## **Bridgeworks in the new town of Cumbernauld**

**B. J. Allan, A.M.I.C.E.**

FIG. 24: MODIFIED STANDARD BEAM (P.C.D.G.)

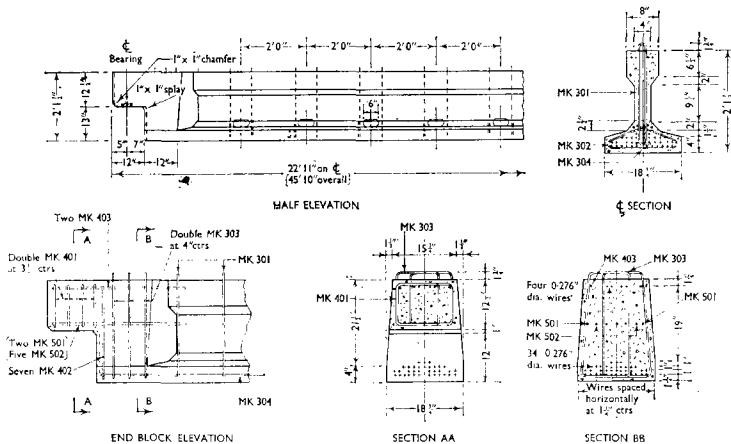
124. In § 40 mention was made of warping and twisting. Was the Author referring to the Prestressed Concrete Development Group standard beams? The Author had implied that it was a design fault. If he meant the P.C.D.G. beam, was it a defect at the production end?

125. It seemed from § 50 that the Author was prepared to consider their use in the future. It would be of interest if the Author could expand his comments on the beams.

150. In § 43 the Author said that he expected further savings by more pre-fabrication and less in situ work. The cross section of the beam in Fig. 3(c) was an ideal cross section combining precast and in situ work, and resulting in a monolithic body. If the in situ topping were omitted, the monolithic action would be lost. The Author said that he had found it necessary to prestress transversely, but later he said that this might be omitted. With an in situ compression flange, transverse prestressing was unnecessary, and it did not improve the efficiency of the structure.

209. Regarding the use of standard beams on future projects, the Author meant

the P.C.D.G. standard beams modified at the end to suit the flush soffit and tested as shown in Figs 10, 11, and 12. The details of such a modified beam were shown in Fig. 24. Although appreciable economies could accrue from the use of these beams, the Author had certain reservations regarding their geometric stability which might be partly due to a defect at the production stage but mainly was due to the design. He felt that a post-tensioned beam, especially one using concentrated prestressing steel, was less likely to warp and twist than a pre-tensioned beam in which it was much more difficult in practice to locate exactly the resultant centre of gravity of the steel and, of course, a small deviation vertically or horizontally of the resultant centre of gravity of the pre-tensioned steel was more than likely to produce distortions. In addition, the M.B.I. type of beam incorporated end blocks and the Author felt that these helped considerably the geometric stability. It would be necessary to provide end blocks in standard pre-tensioned beams as well, if the flush soffit was to be retained. This was actually being proposed for the Seafar/Langlands interchange and it would be interesting to see in practice whether the presence of a type of end block helped to produce greater geometric stability in a pre-tensioned beam.
